July 2018  
FL764A  
NHTSA #18V-194

## Subject: FCCC Motorhome Valve Stem Stabilizers

**Models Affected: Specific Freightliner Custom Chassis X-Line motorhome chassis manufactured November 2, 2016, through January 10, 2018 and equipped with a single drive axle.**

Fig. 1, Valve Stem with New Stabilizer

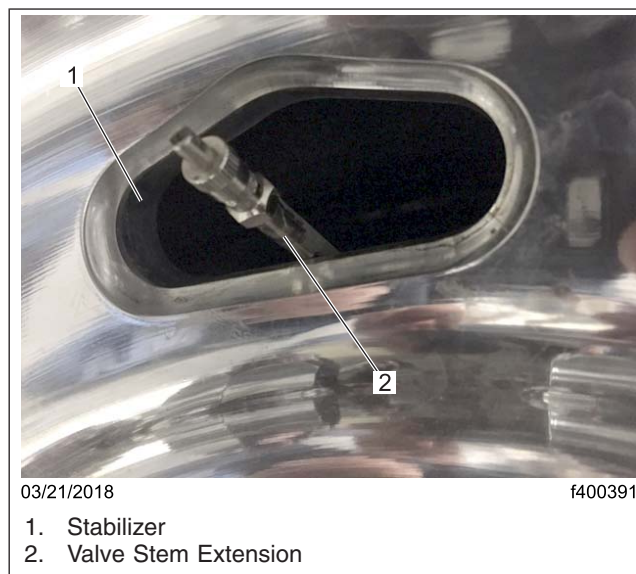
Certain chassis may have been built with an incorrect valve stem stabilizer. It may become dislodged from the wheel, allowing the valve stem extension of the inner wheel to contact the outer wheel, potentially damaging the valve stem and resulting in a loss of air pressure in the inner tire. A loss of air pressure in the inner tire on a motorhome with a single drive axle may overload the outer tire and increase the risk of a crash.

5. Install a new valve stem extension stabilizer. Insert the valve stem through the hole in the stabilizer, then press the stabilizer into place.
6. Clean a spot on the base label (Form WAR259). Write the recall number, FL764, on a completion sticker (Form WAR260), and attach it to the base label to indicate this recall has been completed.
